ITEM # 7  
DECEMBER 17, 1998  
PAGE 1

P98 -102 SPECIAL PERMIT TO ALLOW THE CONSTRUCTION OF A  
PARKING LOT FOR ST. PAUL'S MISSIONARY BAPTIST CHURCH - 4121  
AND 4127 14<sup>TH</sup> AVENUE

(CPC Amended 11-19-98)

## OVERFLOW PARKING FOR ST. PAUL MISSIONARY BAPTIST CHURCH

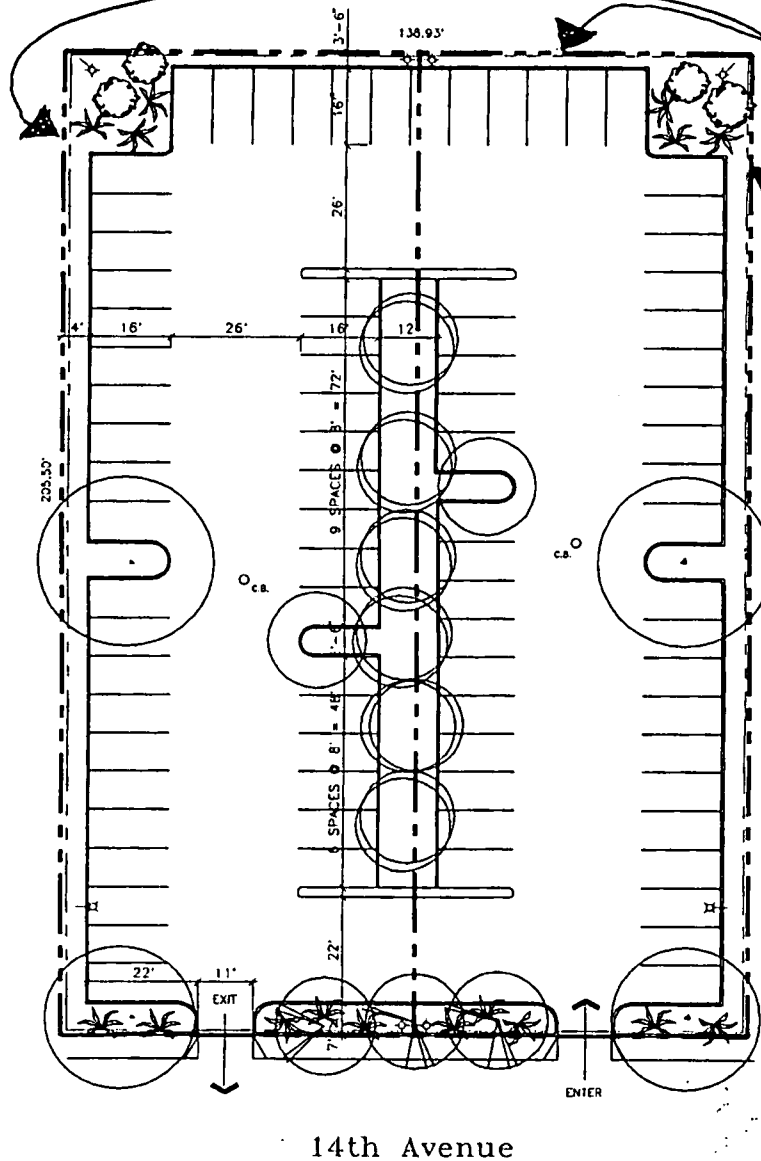
*double sided  
wooden fence with  
metal supports on 3 sides of  
lot  
per C/C  
11-19-98*

8. Automatic sprinklers shall be provided for landscaped areas to the satisfaction of the Planning Division.
  9. <sup>double sided wooden wall with metal supports</sup> A ~~six-foot-high masonry wall~~ is required along the east, west and north property lines around the parking lot. ~~Materials for the wall should consist of split faced block or other units to enhance the appearance of the parking lot.~~ Materials to be used shall be reviewed and approved by Planning staff prior to the issuance of the building permit. (CPC Amended 11-19-98)
